### PERMIT TRACKING FORM

Date Received: 10/13/97	By: tat	PERMIT NUMBER	ACT/007/020
Title of Proposal: Abatement Plans N-97-26-7-1		PERMIT CHANGE #	97G - /
Description:		PERMITTEE	HORIZON COAL COMPANY
# of Copies Required: 5	# of Copies Received: 1	MINE NAME	HORIZON MINE

Title of Change:    Extension of Culvert UC-3 and Adjacent Disturbed Area Boundary	Permit Number: ACT/007/020
	Mine: Horizon Mine
	Permittee: Horizon Coal

Title of Change: <b>Channel Configuration - NOV N97-26-7-1</b>	Permit Number: <b>ACT/007/020</b>
	Mine: <b>Horizon Mine</b>
	Permittee: <b>Horizon Coal</b>

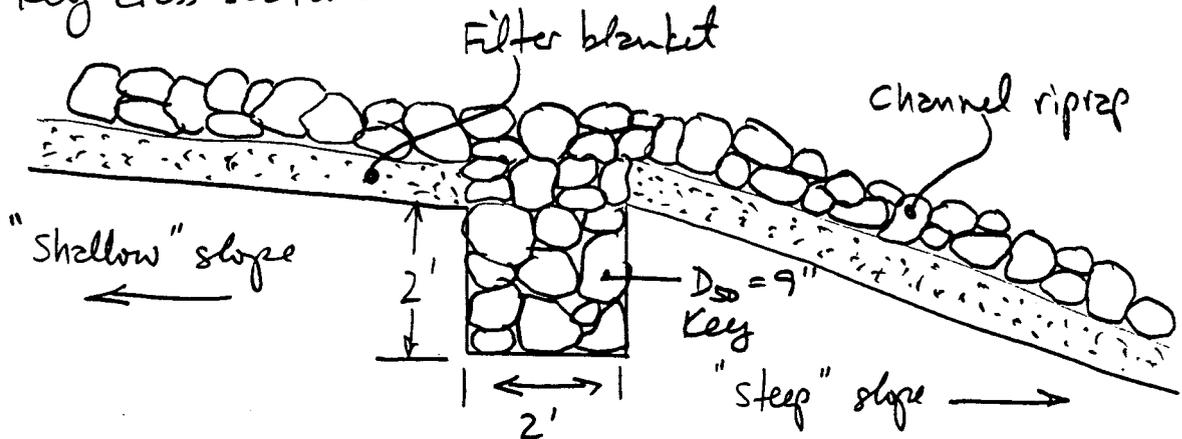
Provide riprap apron at culvert outlet for erosion protection. According to pg 18 of this section:

Channel design downstream from culvert outlet  $\rightarrow$  see pp 17-18 of this section. Extend riprap to top of bank for a distance of approximately 50 ft downstream from the outlet of UC-1 (i.e., to a point around the first bend in the outlet channel). This will provide additional erosion protection on the channel bank.

A change in the grade of the outlet channel occurs at a distance of approximately 100 ft downstream from the outlet of UC-1. To prevent headcutting at this location, install a riprap key into the channel at the change in slope. This key should have a width of 2 ft and a depth of 2 ft below the bottom of the lowest filter blanket (unless bedrock is encountered at a shallower depth). Fill the key with  $d_{50} = 9"$  riprap.

$$\text{Min } d_{50} = 7.4" \rightarrow \text{Use } d_{50} = 8"$$

$$\text{Min. apron length} = 5.5' \rightarrow \text{Use length} = 10'$$

Line area with coarse and fine filter blanket as designed for reclamation channel (6" of each)

Figure I-15. Design of outlet protection — minimum tailwater condition ( $T_W < 0.5 \text{ diam.}$ )<sup>1</sup>

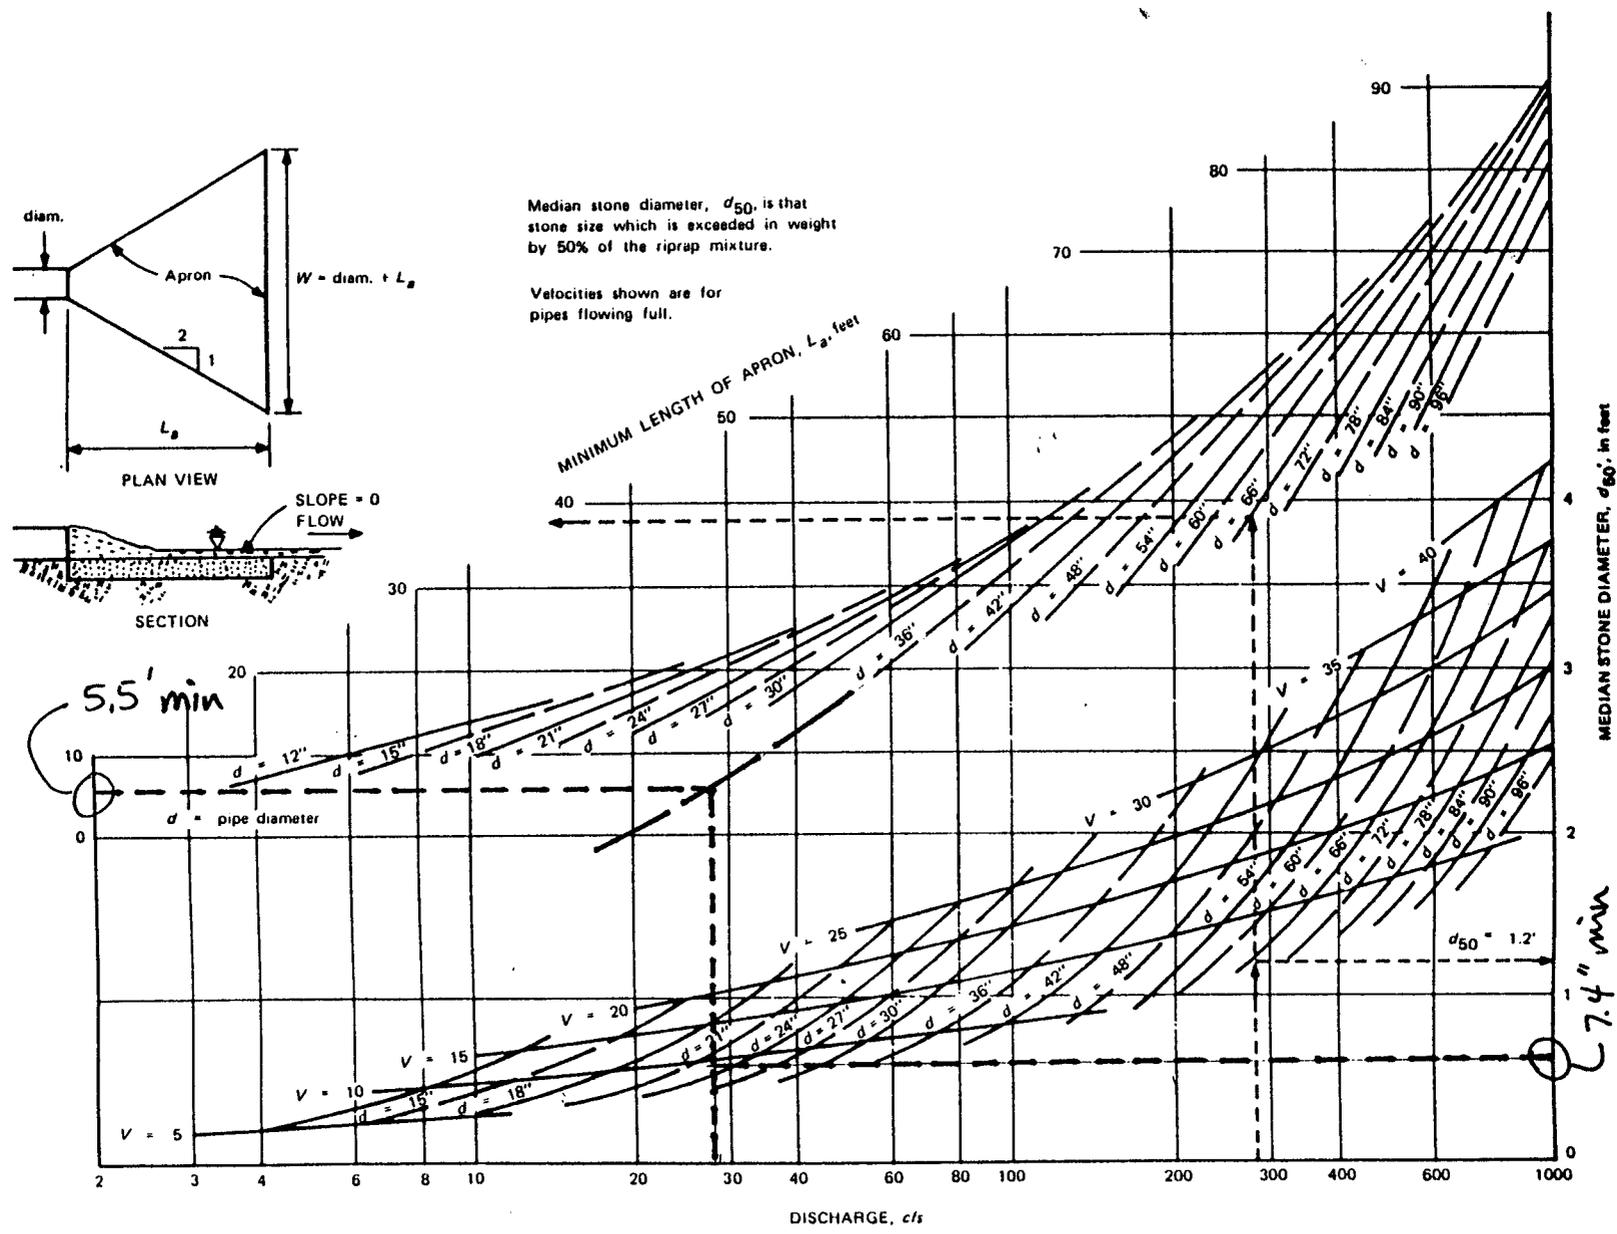
← Outlet velocity

FIG. 2-SIZE OF STONE THAT WILL RESIST DISPLACEMENT FOR VARIOUS VELOCITIES AND SIDE SLOPES

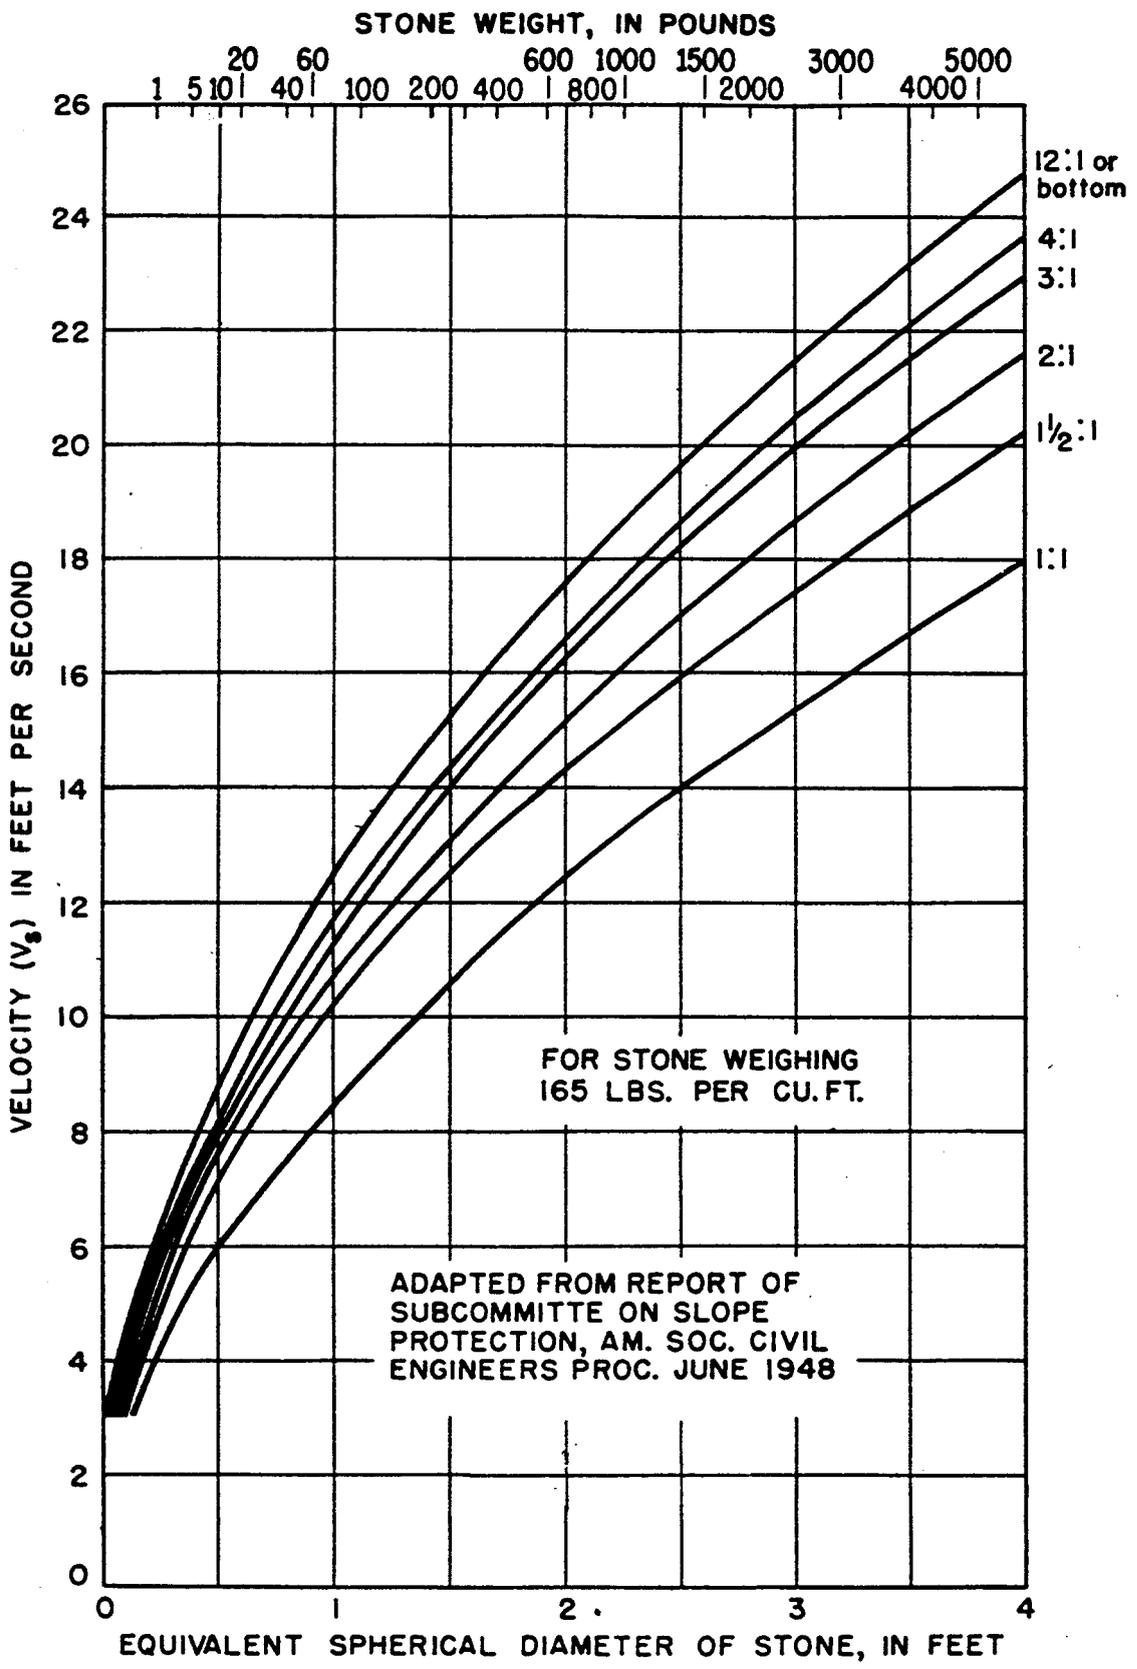
$d_{50} = 9"$  riprap can safely withstand a velocity of 9.4 ft/s against 2:1 side slopes (see pg 18d). Hence, this riprap is adequate.

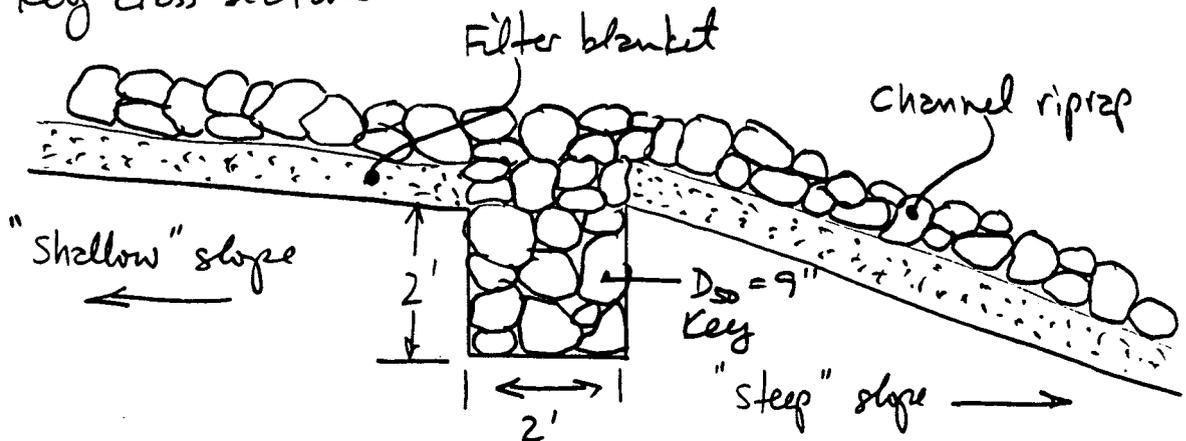
Provide riprap apron at culvert outlet for erosion protection. According to pg 18 of this section:

Channel design downstream from culvert outlet → see pg 17-18 of this section. Extend riprap to top of bank for a distance of approximately 50 ft downstream from the outlet of UC-1 (i.e., to a point around the first bend in the outlet channel). This will provide additional erosion protection on the channel bank.

A change in the grade of the outlet channel occurs at a distance of approximately 100 ft downstream from the outlet of UC-1. To prevent headcutting at this location, install a riprap key into the channel at the change in slope. This key should have a width of 2 ft and a depth of 2 ft below the bottom of the lowest filter blanket (unless bedrock is encountered at a shallower depth). Fill the key with  $d_{50} = 9"$  riprap.

$$\text{Min } d_{50} = 7.4" \rightarrow \text{Use } d_{50} = 8"$$

$$\text{Min. apron length} = 5.5' \rightarrow \text{Use length} = 10'$$

Line area with coarse and fine filter blanket as designed for reclamation channel (6" of each)

Figure I-15. Design of outlet protection – minimum tailwater condition ( $T_W < 0.5 \text{ diam.}$ )<sup>1</sup>

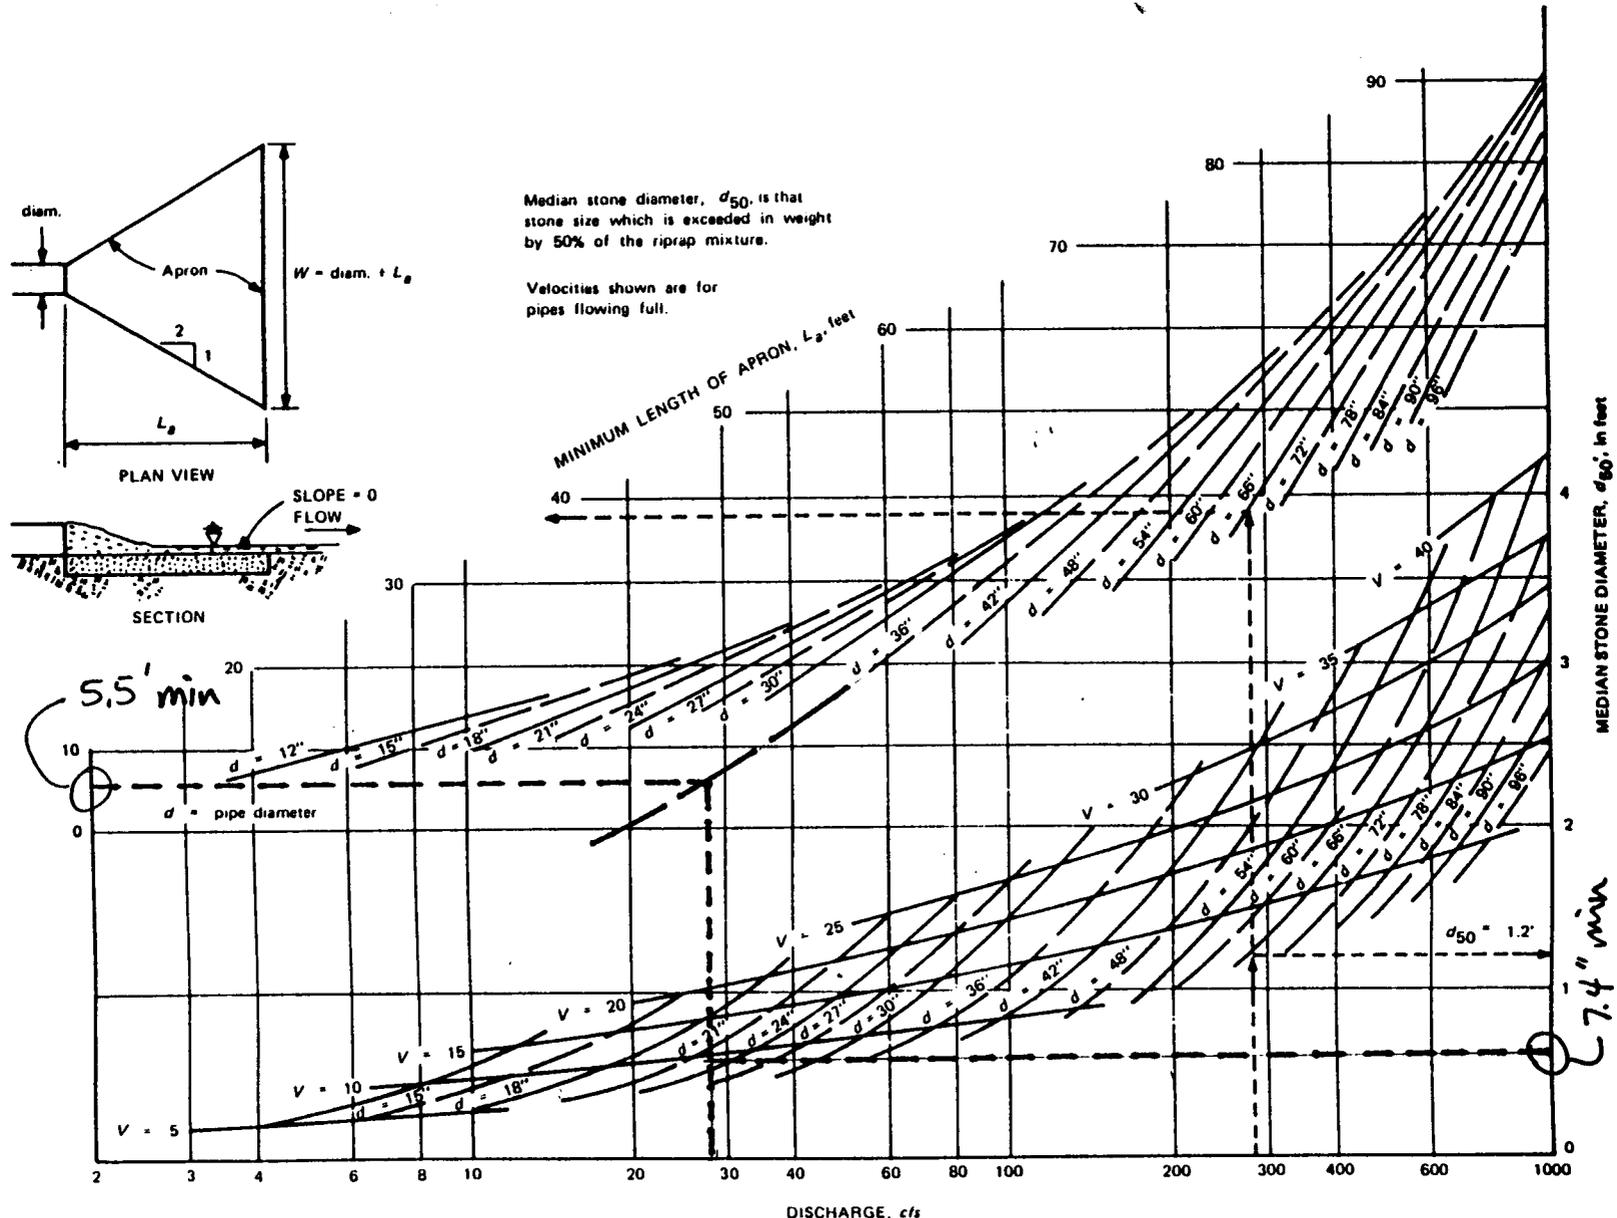
← Outlet velocity

FIG. 2-SIZE OF STONE THAT WILL RESIST DISPLACEMENT FOR VARIOUS VELOCITIES AND SIDE SLOPES

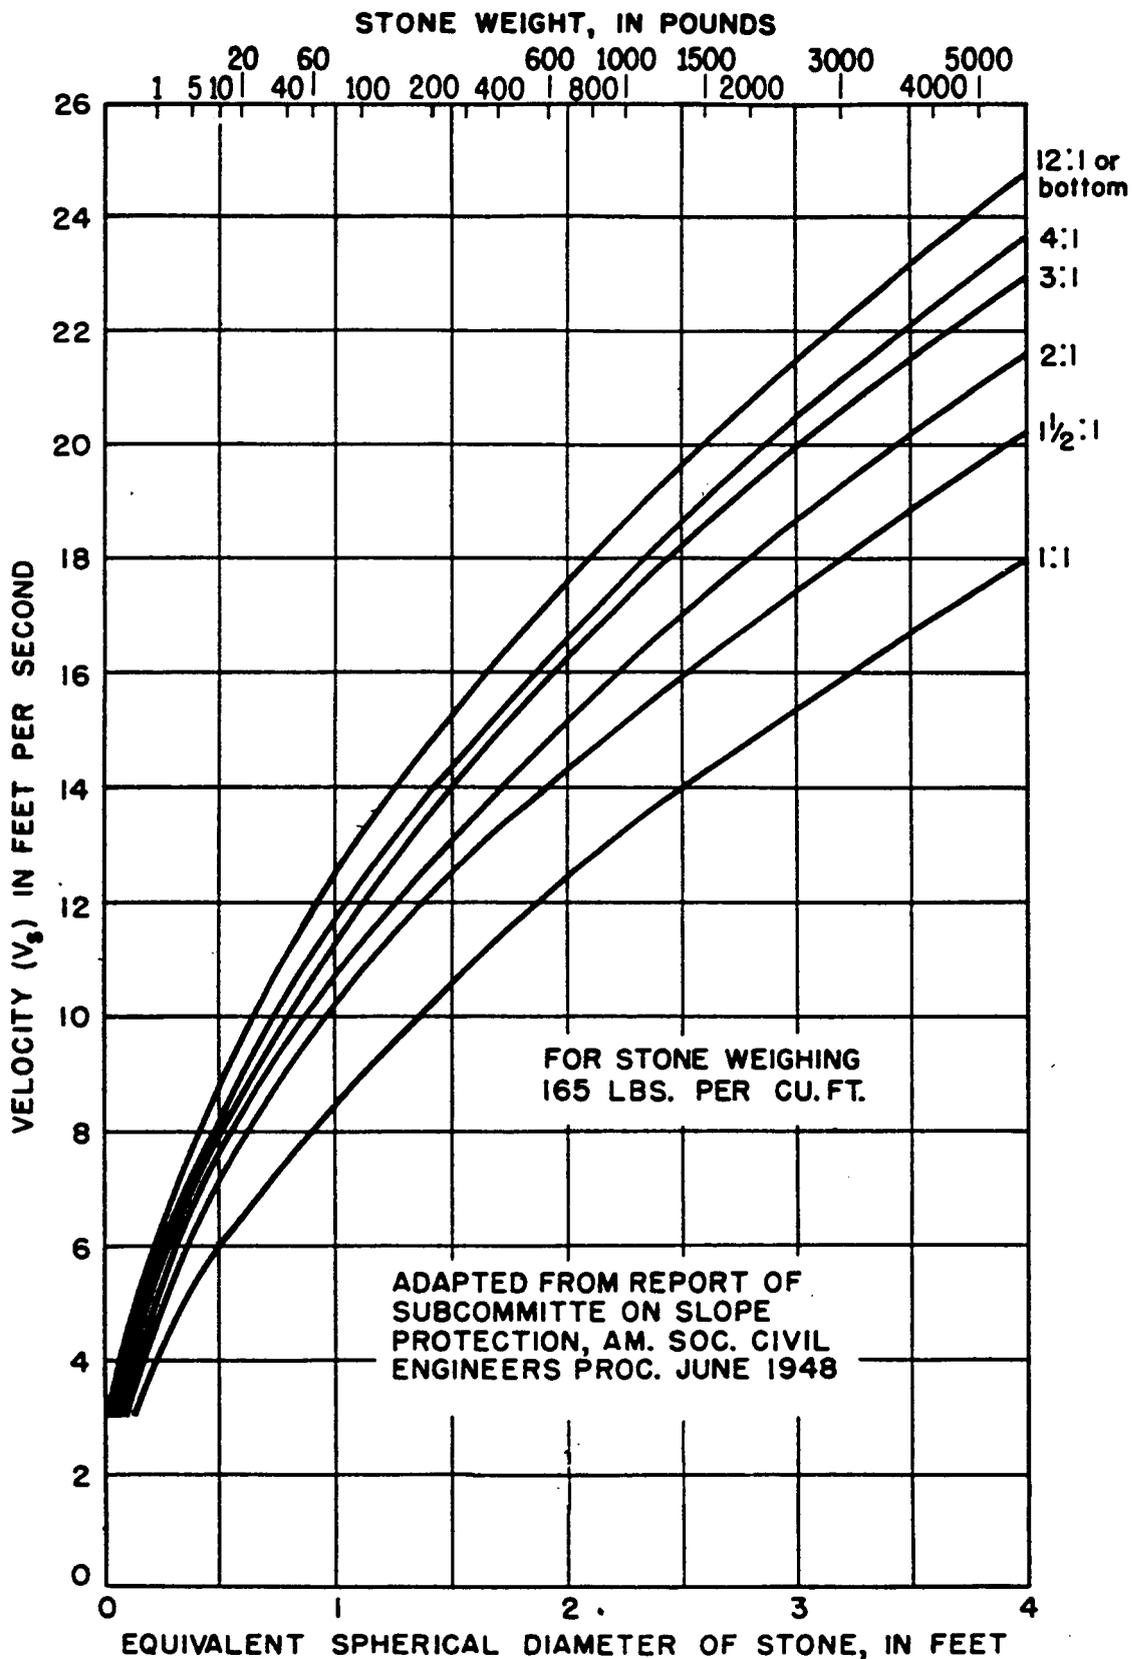
$d_{50} = 9"$  riprap can safely withstand a velocity of 9.4 ft/s against 2:1 sideslopes (see pg 18d). Hence, this riprap is adequate.

FIGURE 7-12A. TYPICAL CHECK DAM CROSS SECTIONS

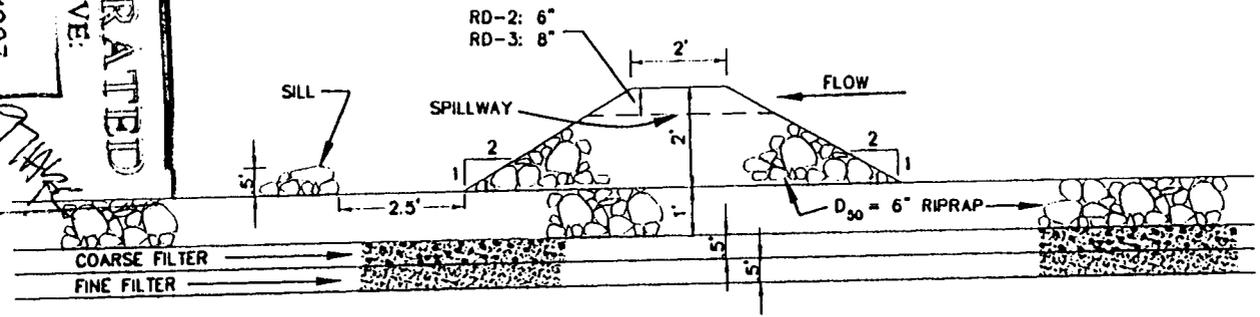
**R645-301-742.324.** 1) Design the Jewkes Creek channel riprap and the riprap key at the transition area to the steep gradient to withstand the velocities for the maximum downstream channel

capacity as identified on page 7-63, wherein, the plan indicates the downstream channel capacity of Jewkes creek is 38.7 cfs. and,  
2) Design the riprap to have a safety factor of 1.3 assuming a combination of rounded and angular riprap is used using the Colorado State University Procedure (Stevens and Simons, 1971, Simons and Senturk, 1977, 1992) for forces on the channel bank as well as the channel bed. Adjust the riprap gradation and other design criteria as necessary. It is recommended that the  $D_{50}$  for check dams be adjusted for the potentially larger flow that could be retained behind the dam prior to sediment deposition.

The recommendations under the findings section above should be incorporated into design and constructed in the field.
